UNITED STATES
DEPARTMENT OF THE INTERIOR
BUREAU OF LAND MANAGEMENTFORM APPROVED
OMB No. 1004-0135
Expires: January 31, 2004**SUNDRY NOTICES AND REPORTS ON WELLS**

**Proposed Plugging Procedures
Cano Petro of New Mexico, Inc.
Cone Federal #16
30-041-20497**

**Cone Federal 16
30-041-20497
Tom R. Cone
May 7, 2024
Conditions of Approval**

Cano Petro of New Mexico, Inc.
Cone Federal #16
API 30-041-20497
WBD Before PA

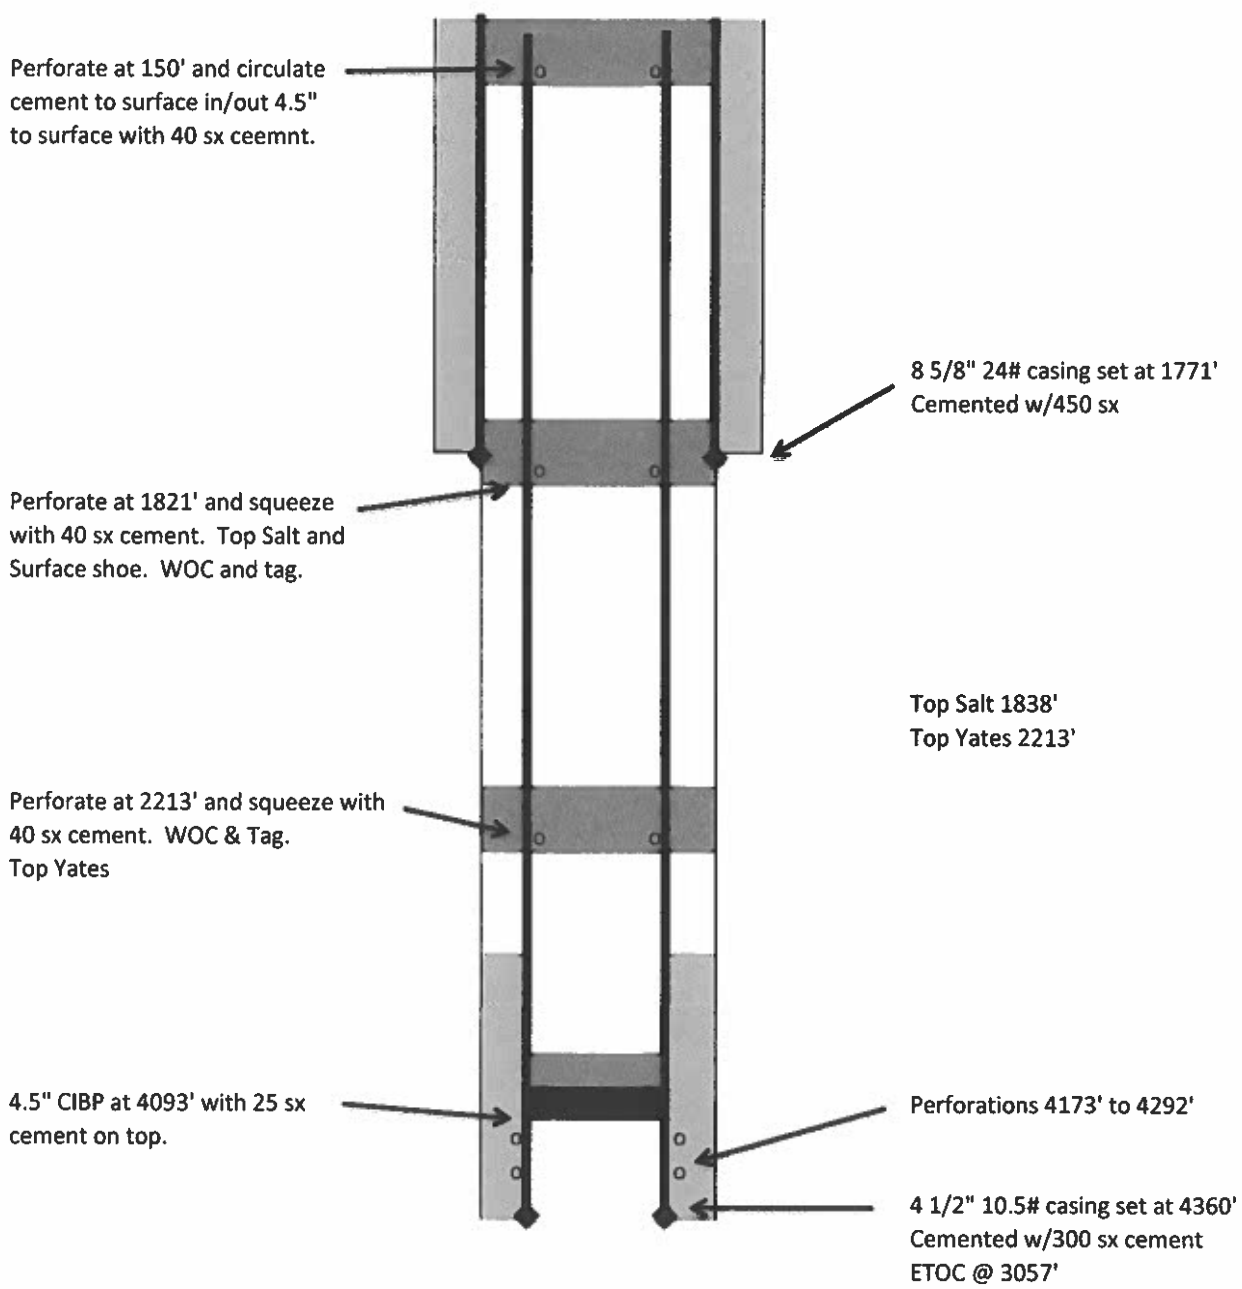
- 1. Operator shall place a CIBP at 4,093' (50'-100' above top perf) and place 25sx of Class C cement on top. WOC and TAG.**
- 2. Operator shall place a balanced Class C Cement plug from 3,230'-2,853' to seal the Queen and Grayburg Formations.**

- 3. Operator shall perf at 2,263' and squeeze cement class C cement to 2,042' to seal the Yates and bottom of Salt. WOC and TAG.**
- 4. Operator shall perf at 1,890' and squeeze cement class C cement to 1,721' to seal the top of Salt, Rustler and 8-5/8" casing shoe. WOC and TAG.**

- 5. Operator shall perf at 150' and squeeze cement class C cement to surface as proposed.**
- 6. Dry hole marker must be below ground.**
- 7. Surface reclamation will need to be completed once the well bore has been plugged. Please contact rflores@blm.gov for additional information.**
